ADDENDUM

PROJECT: Bryan Health
Bryan Medical Center, West
Independence Center, New Facility
Lincoln, Nebraska

AD-2

DATE ISSUED: Friday, March 22, 2013

1 Foundation Plan
1/8" = 1'-0"

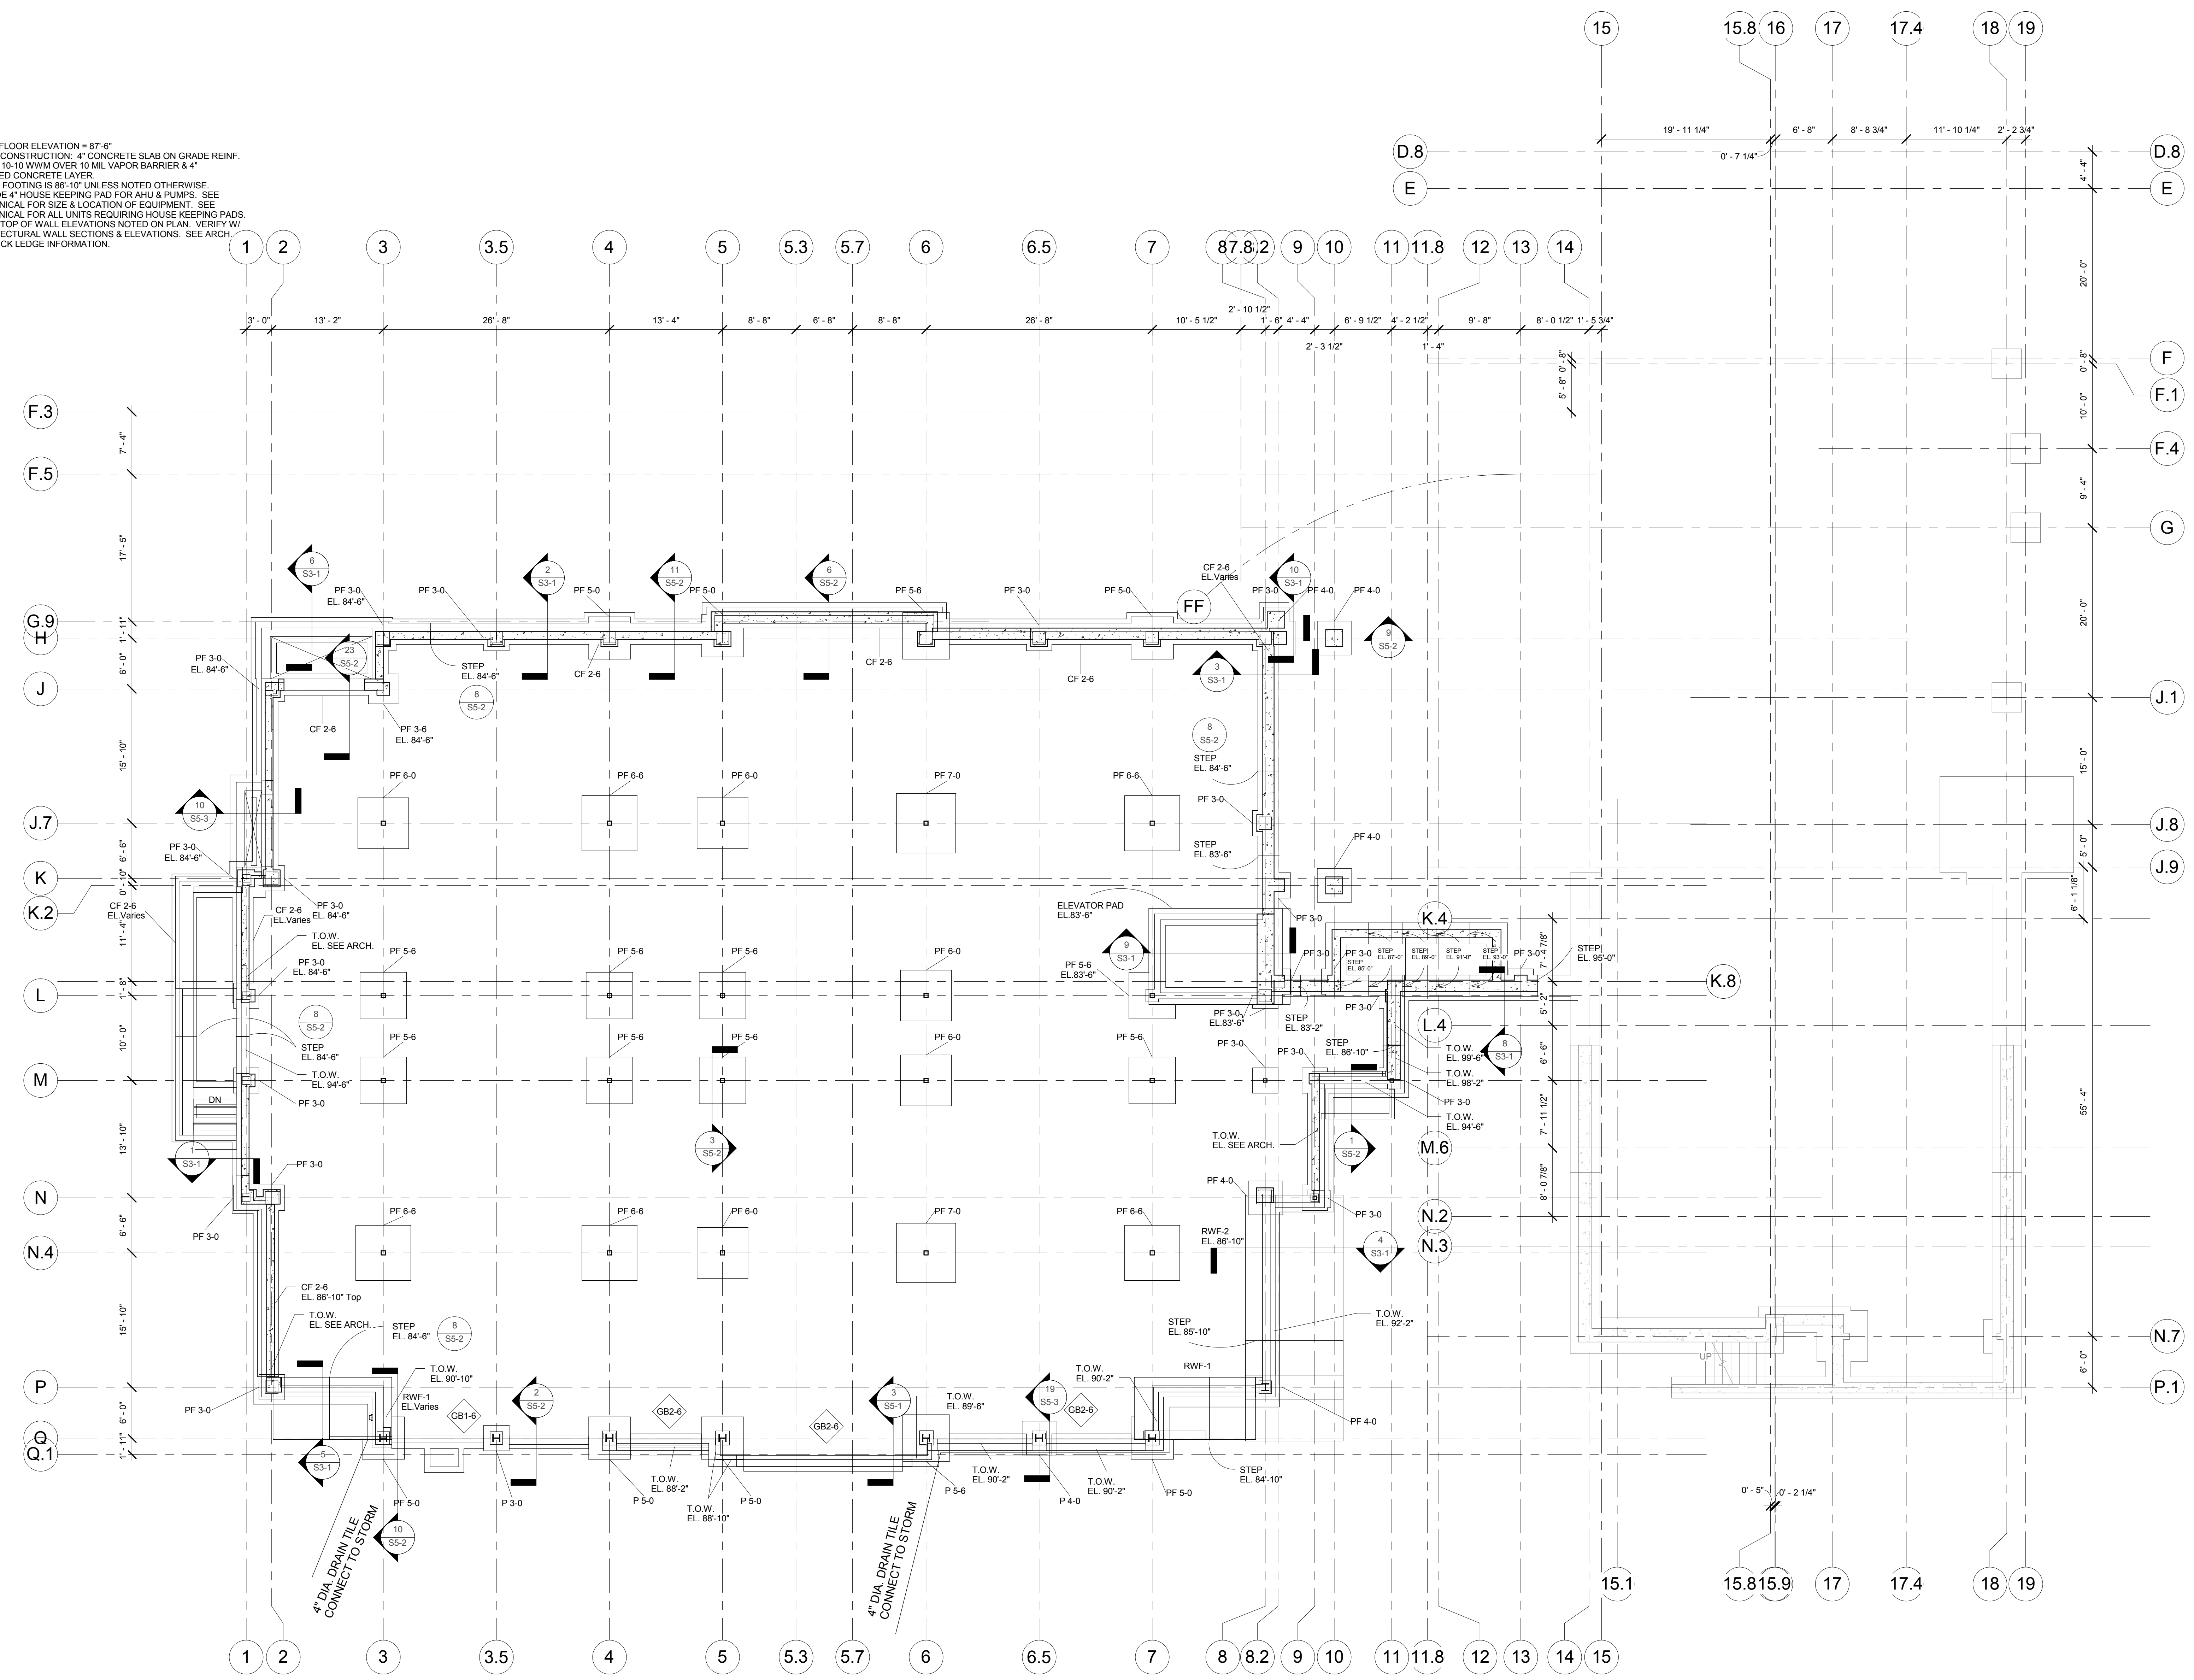
In reference to drawing Sheet S1-1, Foundation Plan, see attached Foundation Plan S1-1.2 for revisions to the Foundation Plan. Note that this is a full size sheet.

Drawing #
2.1

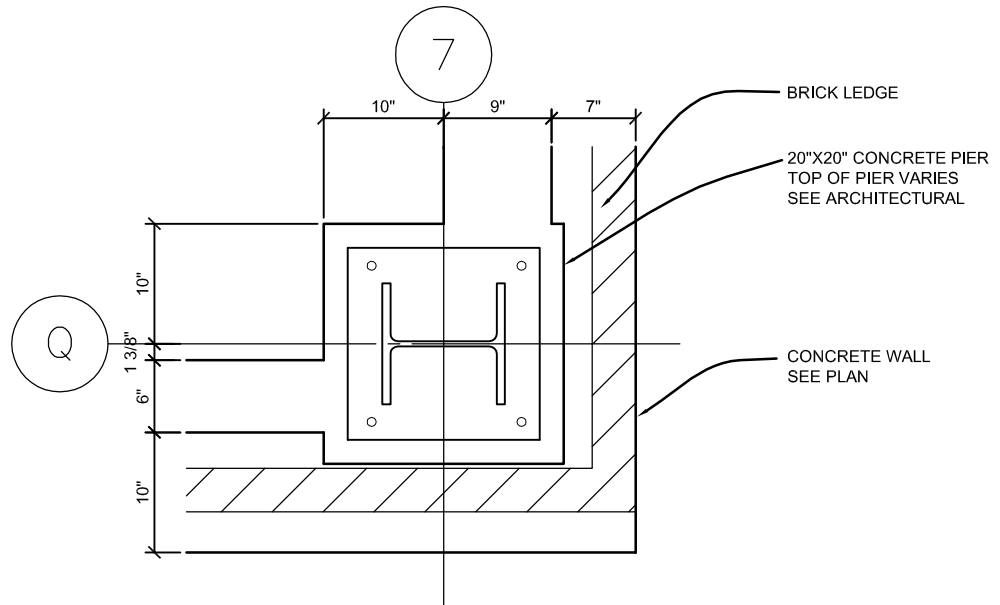
In reference to drawing Sheet S5-1, Details, see attached sketches 2.1-S5-1, 2.2-S5-1, and 2.3-S5-1 for additions to detail 2 and sheet S5-1.

3 Grade Beam Detail

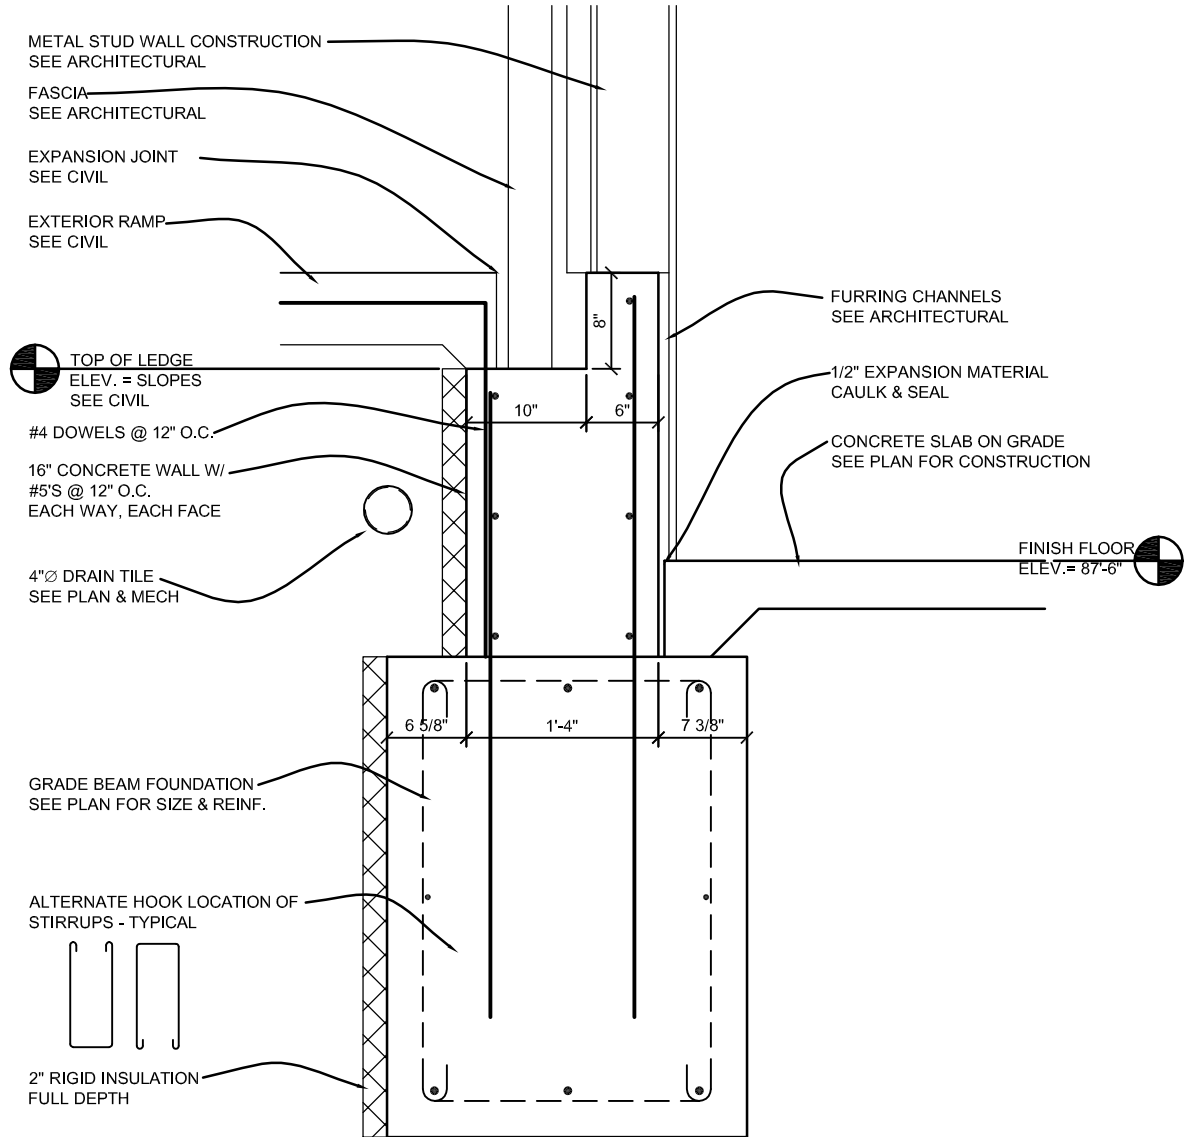
In reference to drawing Sheet S5-1, Details, see attached sketch 3-S5-1 for new detail to be added to sheet S5-1.

2 **Grade Beam Detail**
Scale: 3/4"=1'-0"

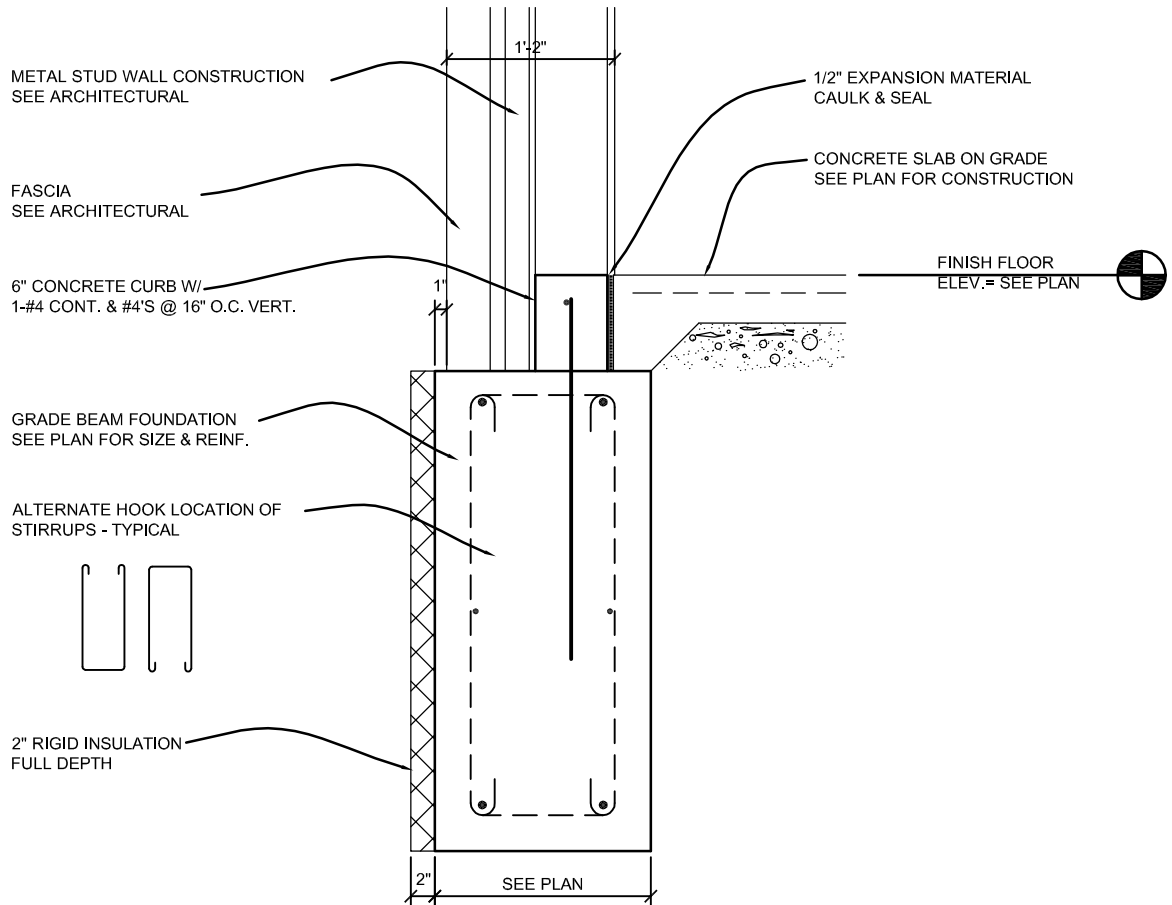
In reference to drawing Sheet S5-2, Details, see attached sketch 2.1-S5-2 for revised Grade Beam Detail from sheet S5-2.

19 **Column & Pier Detail**
 Scale: 3/4"=1'-0"

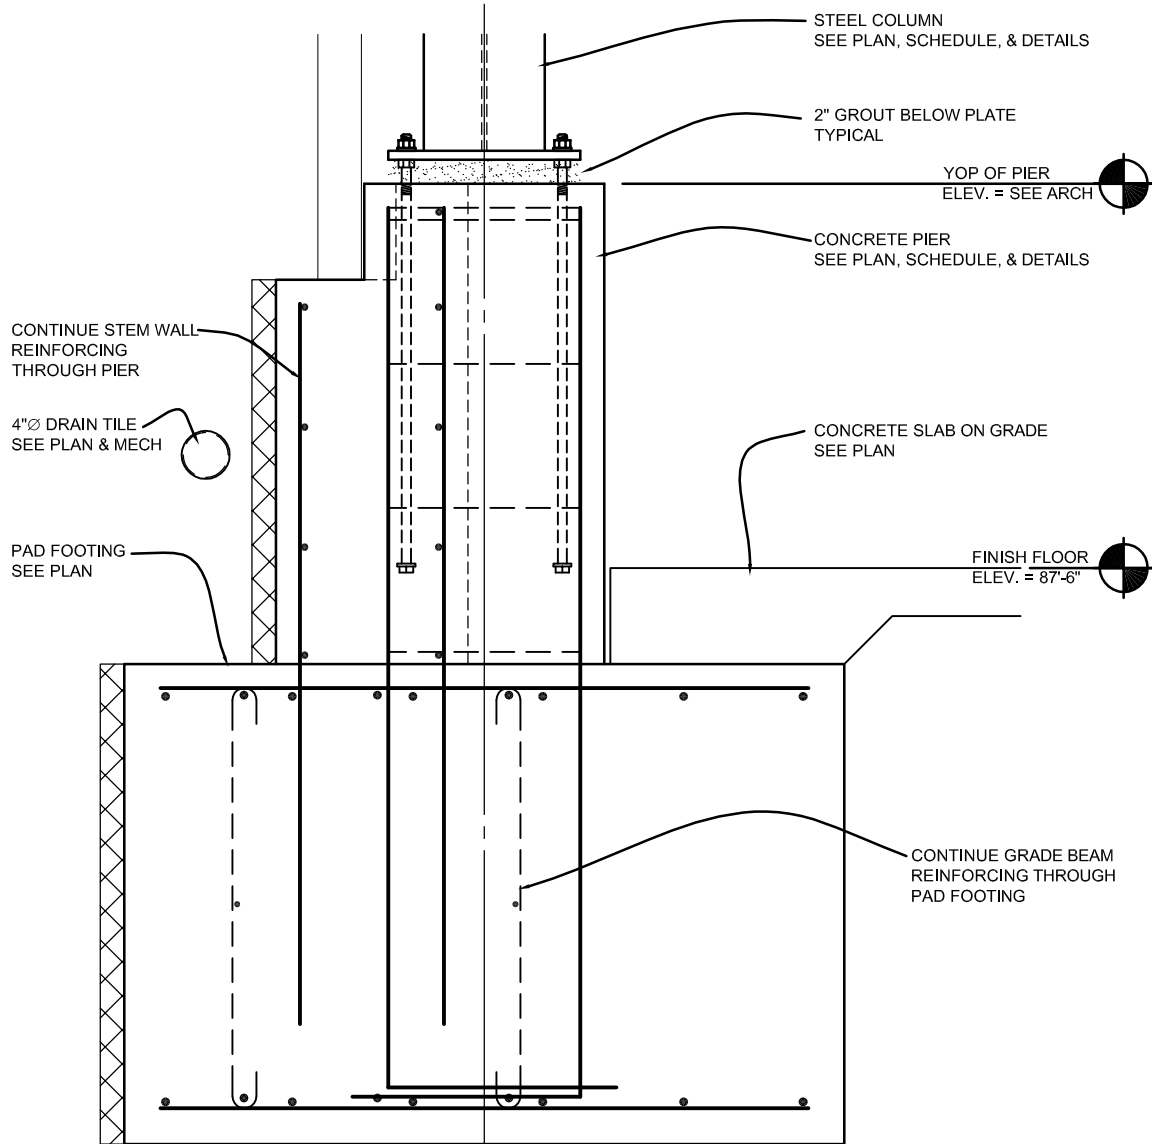
In reference to drawing Sheet S5-3, Details, see attached sketch 19-S5-3 for new Pad & Pier Detail from sheet S5-3.

From Sheet	for CA use:
Drawing #	
AD1-1F.1

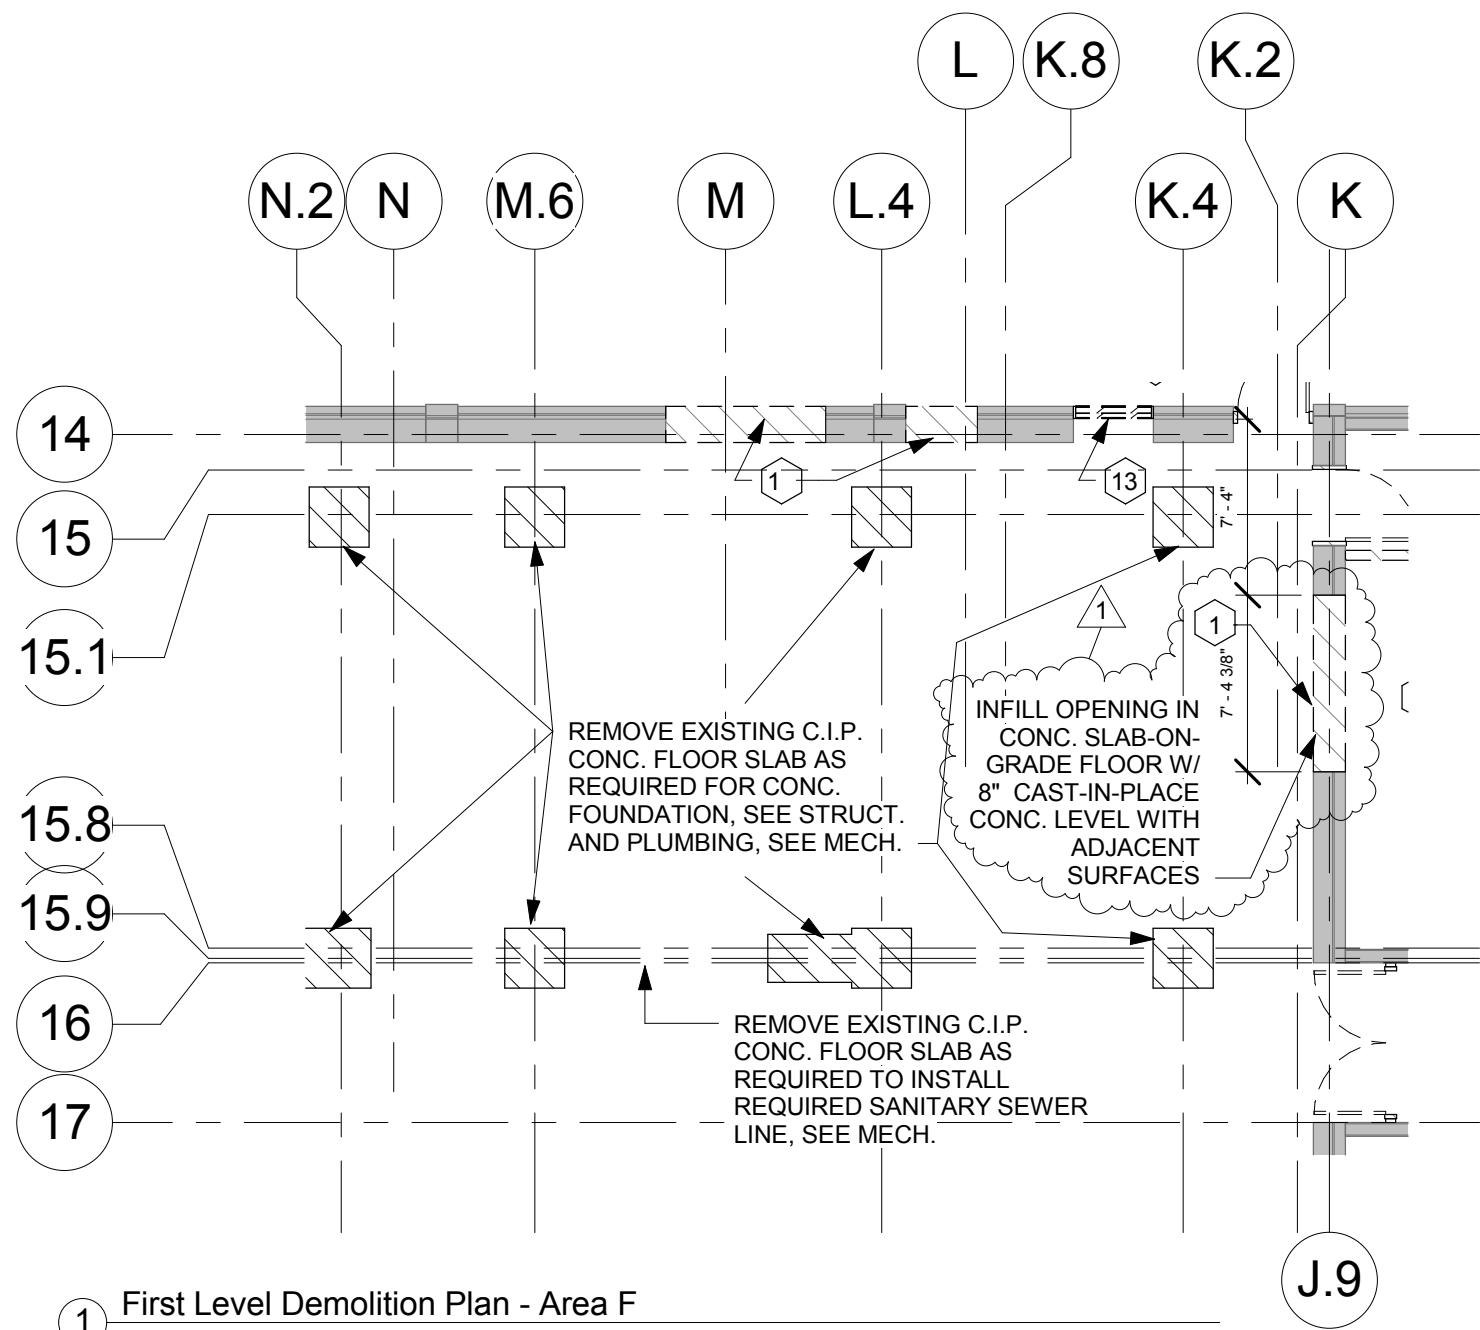
In reference to sheet AD1-1F – Demolition Plan – Area F, see attached Supplemental Drawing AD1-1F.1 for note added note regarding floor patching at masonry wall opening.
